**CHANGE ORDER**

ORDER NO.: 4  
DATE: December 10, 2020  
AGREEMENT DATE: April 3, 2019

NAME OF PROJECT: Wilbarger Creek Wastewater Treatment and Collection System Improvements

**RE: Wilbarger Creek Wastewater Treatment And Collection System Improvements  
CPR 020 – Bearing Walls**

<b>15</b> SHEET	<b>CITY OF MANOR</b>		
	SCALE: AS NOTED DWN: JGA    DESIGN: FTP    DATE: MAR 2019		
	DWG. NO. AS NOTED    JOB NO. 100-068-20

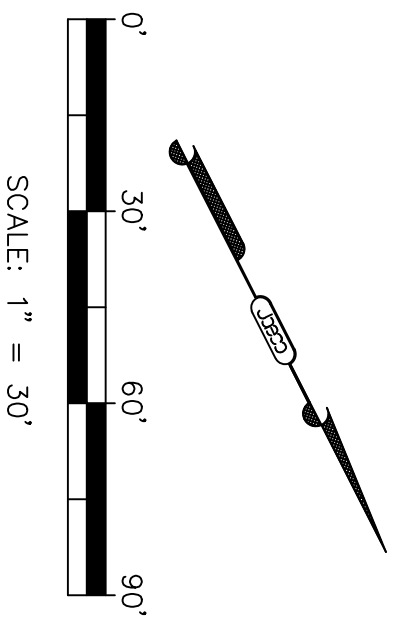
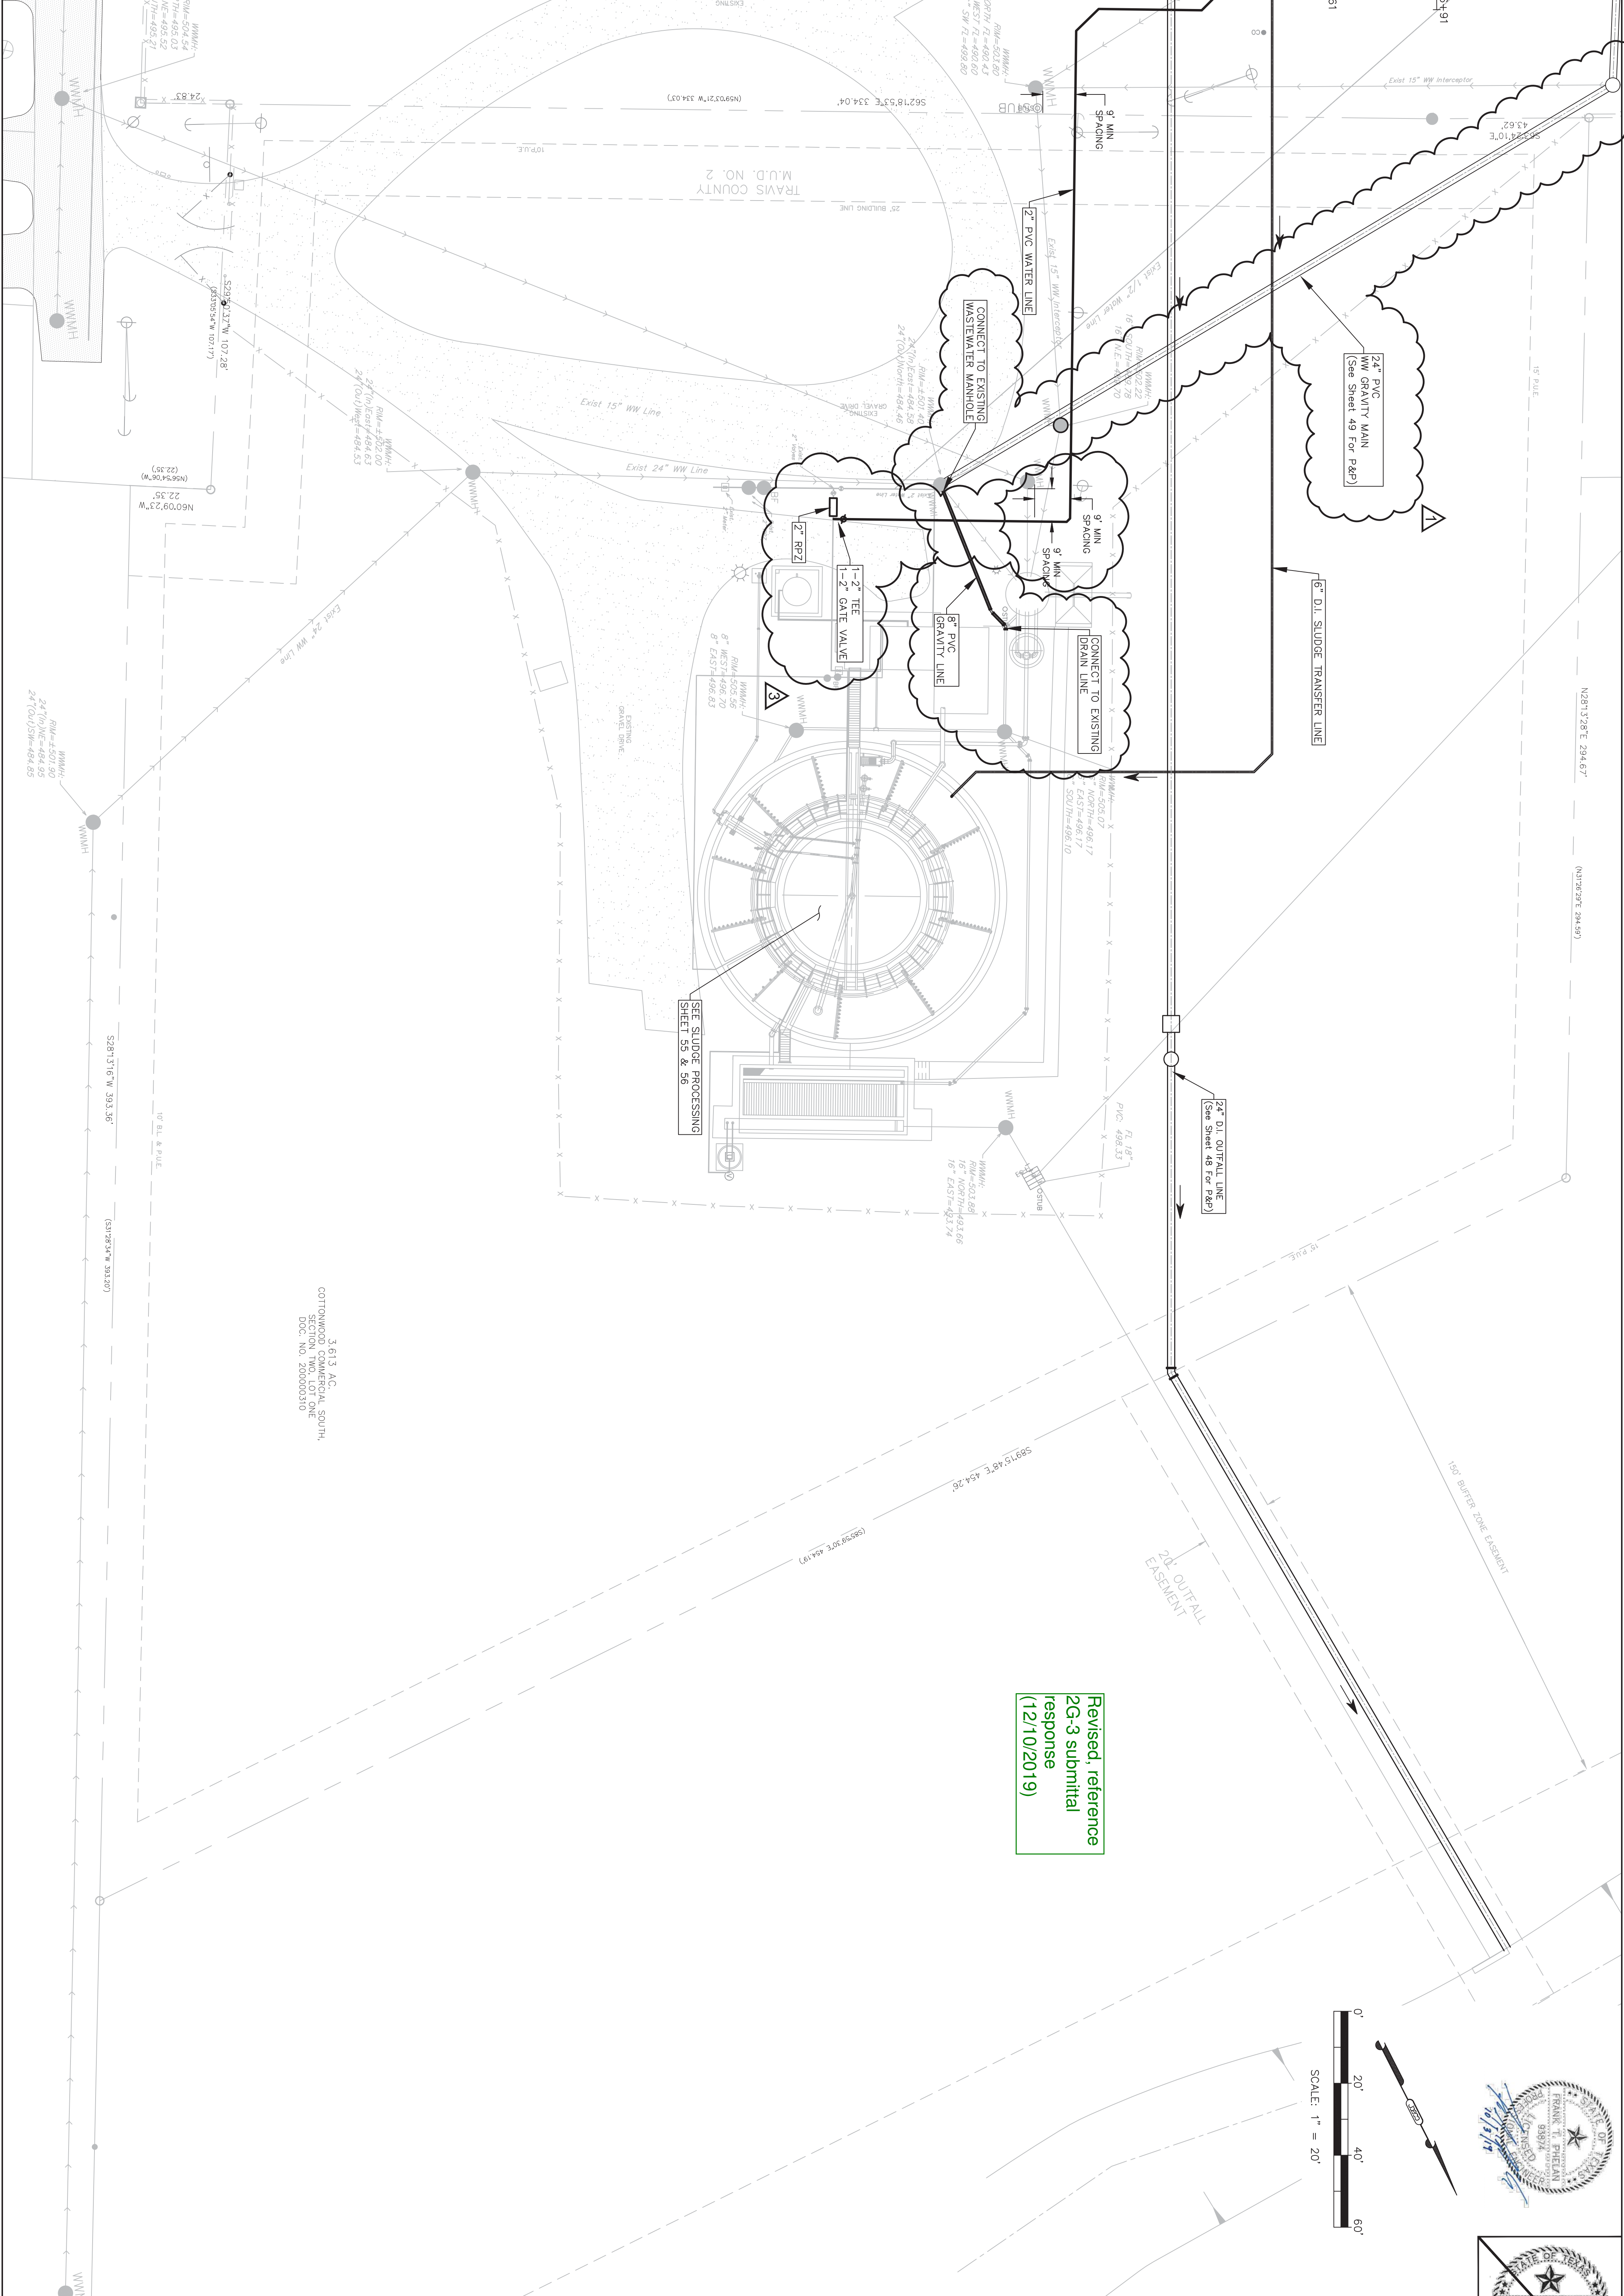
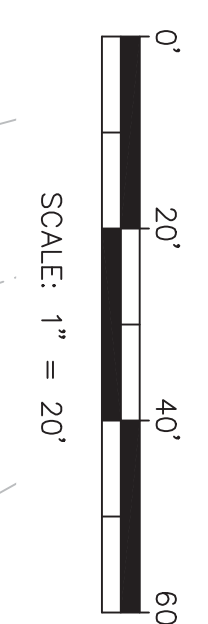
Excel Construction Services is pleased to offer the following pricing for additional sidewalk at the sampler location and 2” waterline revisions. Please reference attached revised plansheets 6 and 15. See below pricing and attached breakdown for review. We are requesting (2) additional contract days for this work.

NO.	DATE	REVISIONS	APPV.
7	10/01/20	ADDED SIDEWALK AND WATER/WASTEWATER SAMPLER

NO.	DATE	REVISIONS	APPV.
10/03		Relocated RP2 and 2" Water Line	
08/19		Revised Elevs. and Pipe Slopes

SHEET  
**S.3.1**  
of 48

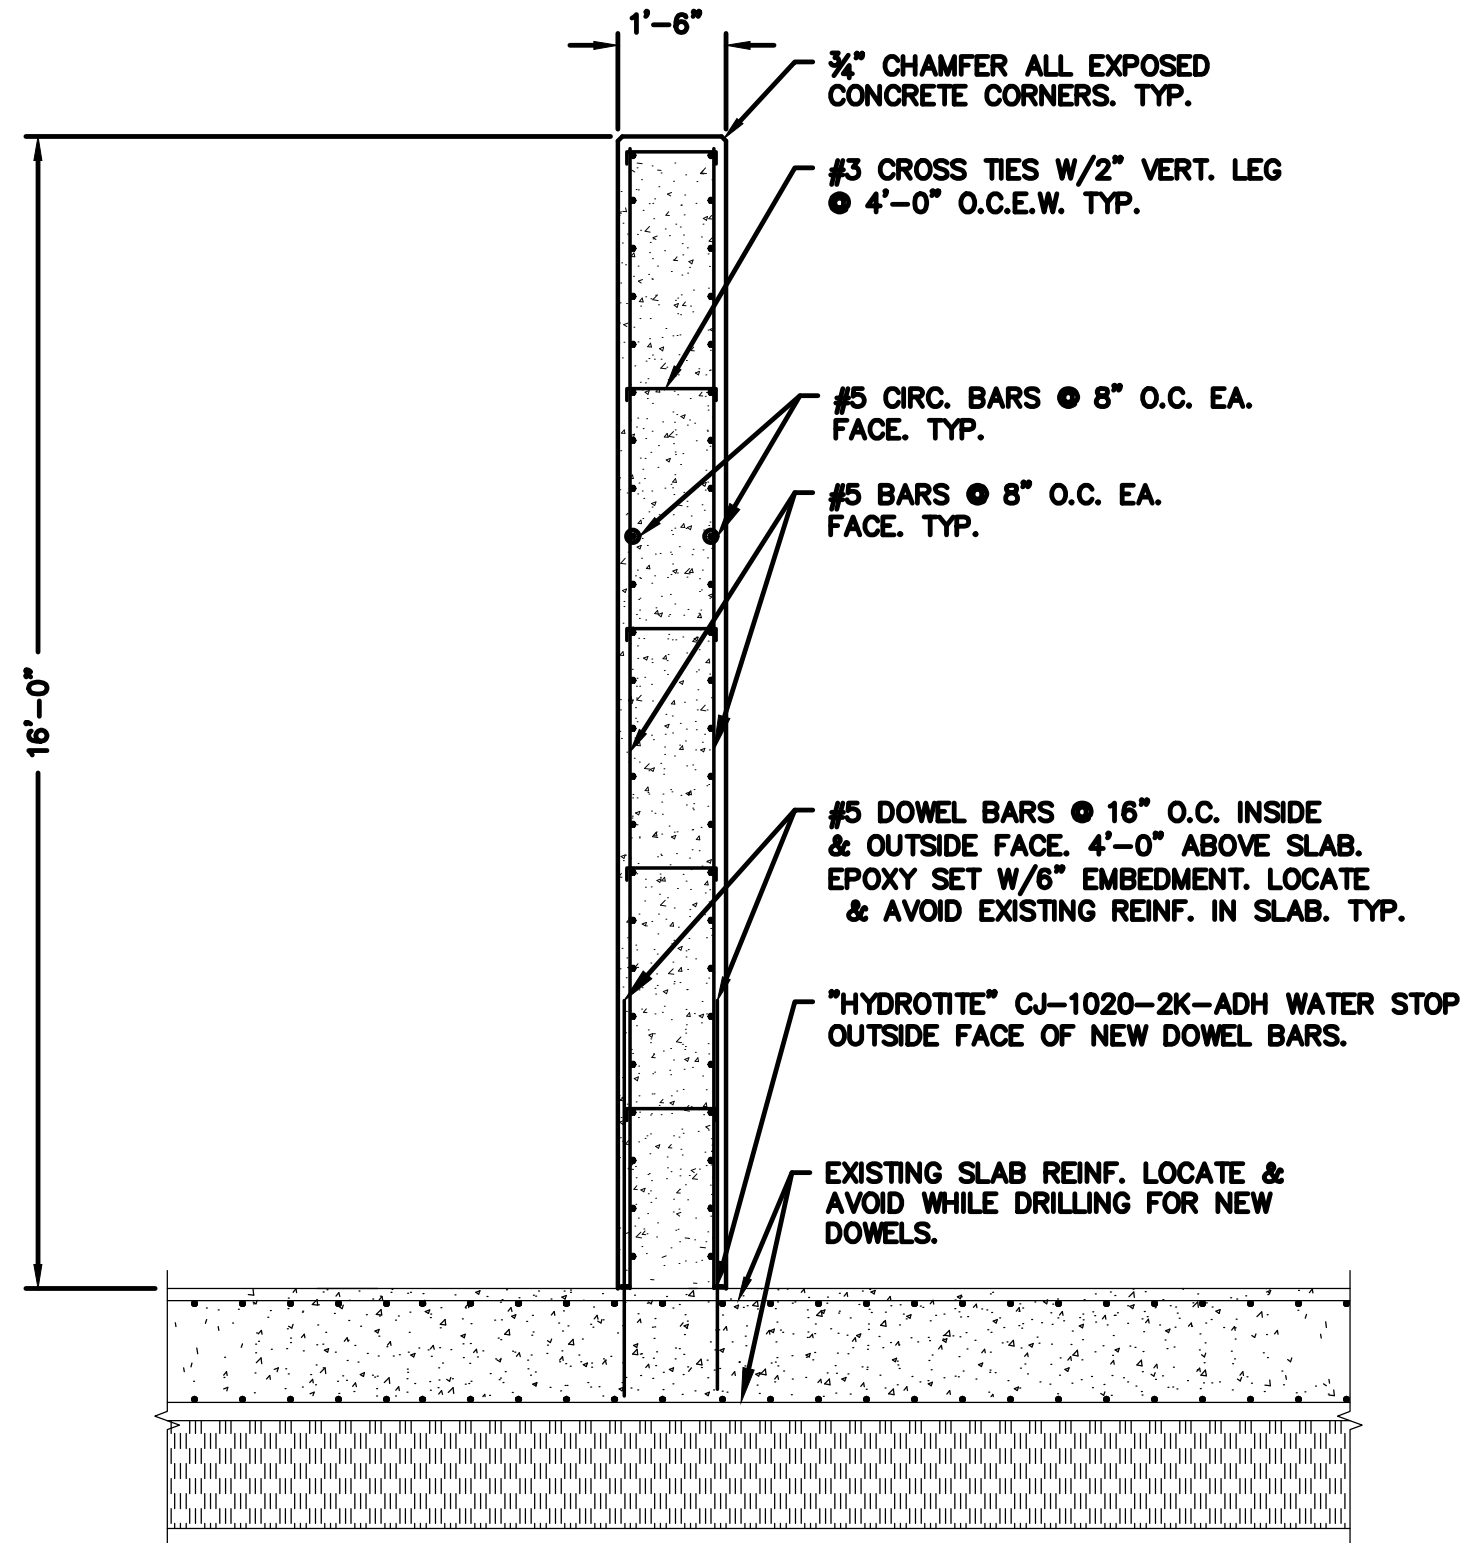
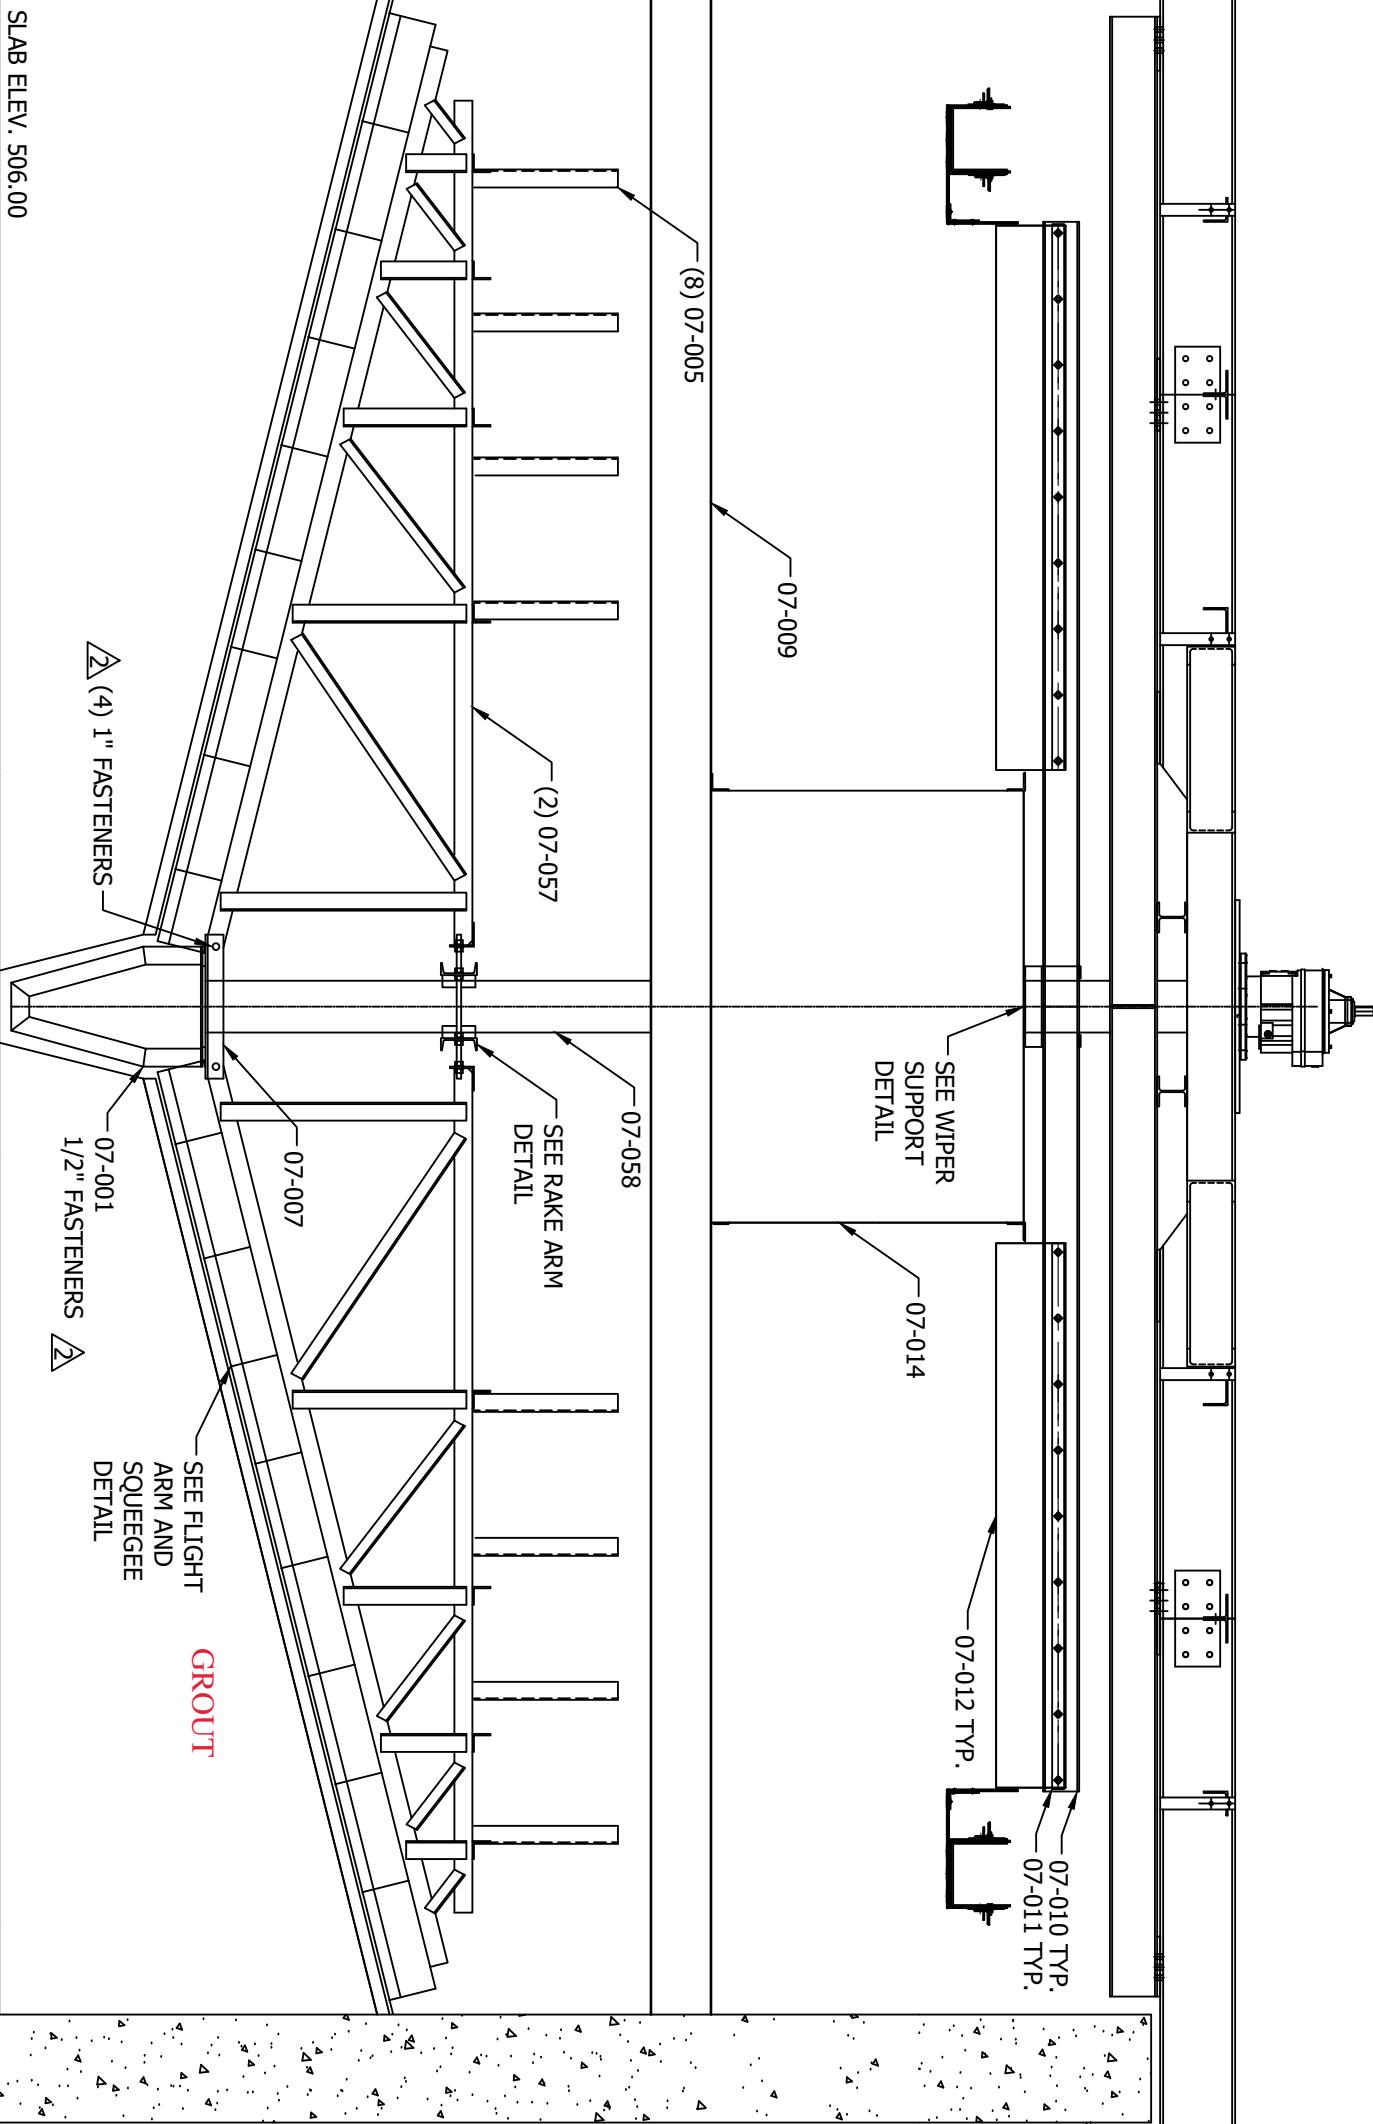
Excel Construction Services is pleased to offer the following pricing for the new 16' wall and grout floor at the sludge processing plant. Please reference S.3.1 plansheet issued 10/12/20 and GH Systems thickener drawing. See below pricing and attached breakdown for review. We are requesting (35) additional contract days for this work.

A wall was added at the Sludge Plant - this is the cost and material associated.  
5.4 tons @ \$950 per ton + \$100 for supports
